AERONAUTICAL CHARTING MEETING
Charting Group
Meeting – October 24 - 25, 2018

RECOMMENDATION DOCUMENT

FAA Control #18-02-327

Subject: U.S. Government IAP Chart Modernization

Visibility with and without ALS

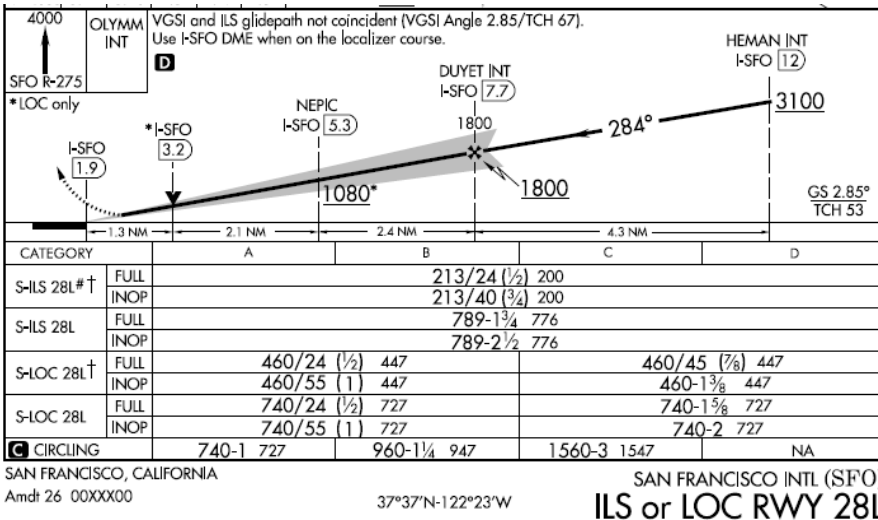
- Incorporate the effects of inoperative components into the lines of minima for each approach category. The purpose of this proposed change is to furnish the pilot with a Minima Table providing minimums for all situations. Today, the pilot must refer to the Inoperative Components Table of the TPP to determine corrections to the published visibility and to the MDA or DA with the failure of the approach lighting system, runway touchdown zone or centerline lights, or RVR systems. Below is an example of the proposed change:

SM visibility provided for RVR outage and for military pilots

1. The “Stacked” option:

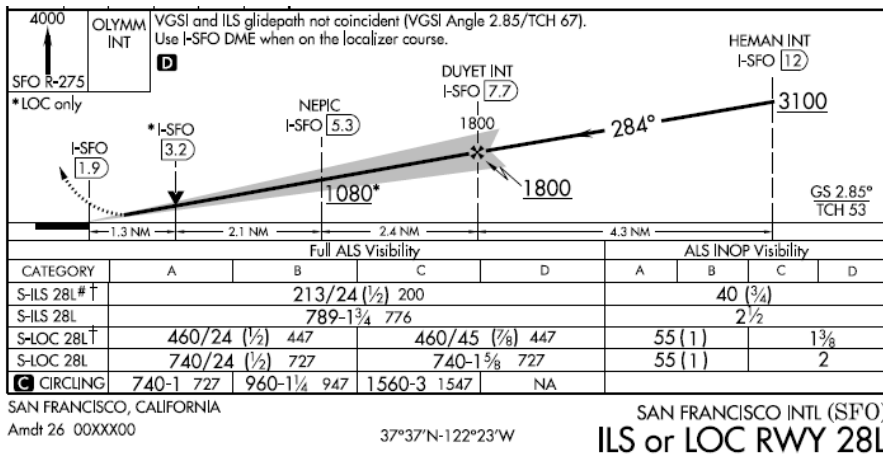
NBAA proposes Two possible presentation options for depicting the lines of minima:

Rune Duke, AOPA, reported that AOPA had reached out to their membership in a survey to see how their pilots felt about these proposed changes. The [conclusion of the survey](#) found that pilots prefer the side-by-side minima depiction 2:1 over the stacked minima depiction or the current depiction. There were concerns expressed about the loss of the sketch, however only 23% preferred the current depiction over the newer alternatives. Pilots surveyed by AOPA also questioned the need to depict RASS on the charts.
